**Re: Response to Comments on Sheet Pile Wall Repair Work Plan
Metal Bank NPL Site, Philadelphia, Pennsylvania, October 2014**

Sheet Pile Wall Repair Work
Plan
Metal Bank Cottman Avenue
Superfund Site

Date:
**November 2014
(Revision #1)**

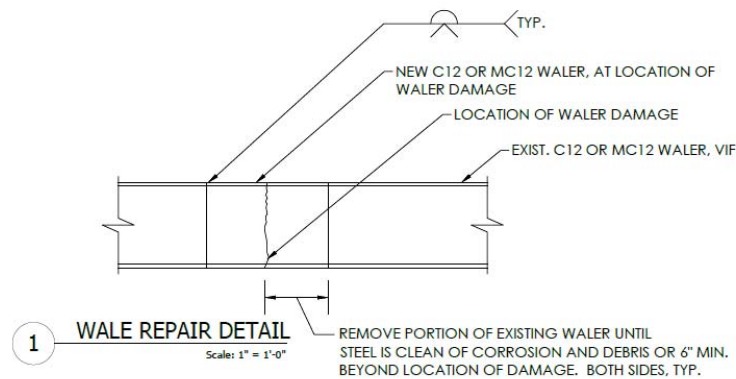
Comment 3: *The extensive use of riprap will obscure direct inspection of the wall below elevation 0. This will eliminate the ability to observe any seepage / sheen potentially associated with the failure of other components of the remedy.*

Response: We agree that it is necessary to evaluate whether PCB oils are migrating off-site. However, we do not share the commenter's concern that the placement of riprap limits our ability to do so. As part of the final remedy, a light nonaqueous-phase liquid (LNAPL) interceptor trench was installed near the sheet pile wall to determine if PCB oils were at risk of migrating off-site. The proposed placement of the riprap will not affect the LNAPL trench or its ability to evaluate the presence of PCB oils. In addition, it warrants stating here that no oil sheens have been observed in the LNAPL trench since its construction in 2009 and PCB

concentration in groundwater at the Site are consistently below drinking water standards (even though these standards do not apply to this site).

3.2 Option 2 – Upland-side Repairs

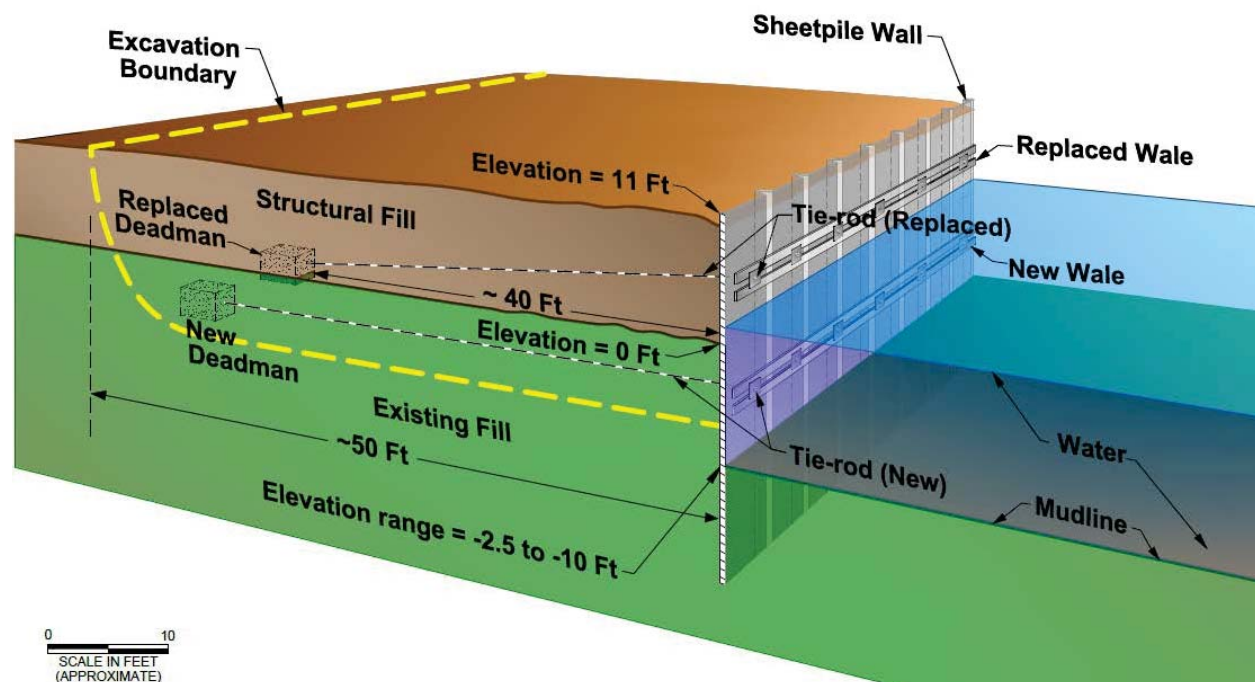
Comment 2: *The proposed berm is permanent fill that requires mitigation under the Clean Water Act. Alternative repair options must be considered as part of the mitigation analyses. Any work plan or repair proposal must include a mitigation plan.*

Comment 4: *It should also be noted that proposed berm will eliminate habitat for aquatic biota. As such, it constitutes natural resource damage in perpetuity that was not included in the remedy evaluation. Because of this and the previously noted 404 considerations, the BTAG strongly recommends that alternative repair approaches with minimal or temporary effects to the river habitat be considered and presented for consideration.*

In a second statement, the commenter states that alternative repair options must be considered. As described in our response to Comment 1, we have added an alternative repair option to the updated work plan (section 3.2). The alternative option is the "upland option", which consists of repairing the cracked waler and installing an additional row of deadmen, offset from the original deadmen and located at a deeper soil depth and at a greater distance from the sheet pile wall. The new row of deadmen would be secured to an additional waler with tie rods, similar to the original deadmen installation. Significant excavation would be required under this approach. With the upland repair option, greater than 1 acre of the soil cover would have to be removed and replaced. In addition, the surface vegetation in the disturbed areas would have to be restored, which would take greater than 3 years to re-establish.

Though we have included a description of this alternate approach in the updated work plan, we will not be recommending this alternative approach be implemented at the site for the reasons described below. Compared to the originally proposed repair option described in the work plan, the alternative option:

- Does not minimize disturbance of previously constructed remedy components, such as the upland soil cap, the underlying polychlorinated biphenyl (PCB) contaminated soils, or the nearshore backfill area;
- Will result in some site soils migrating into the river environment during remedy implementation, despite implementation of best erosion control practices;
- Does not represent a practical approach that can be constructed in the near term; and,
- Does not minimize the disturbance of the restored upland and intertidal habitat adjacent to the sheet pile wall.

A second option to address the issues identified during the geotechnical analysis is to repair the cracked waler and install an additional row of deadmen, offset from the original deadmen and located at a deeper depth and at a greater distance from the sheet pile. The new row of deadmen would be secured to an additional waler with tie-rods, similar to the original deadmen installation (Option 2). These repairs address both the structural and global stability of the sheet pile wall under low water conditions. A schematic of the proposed Option 2 is shown below. As shown in the plan view image, Option 2 would require the excavation of soil cap and underlying contaminated soils from the sheet pile to the new line of deadmen, approximately 50 feet inland.
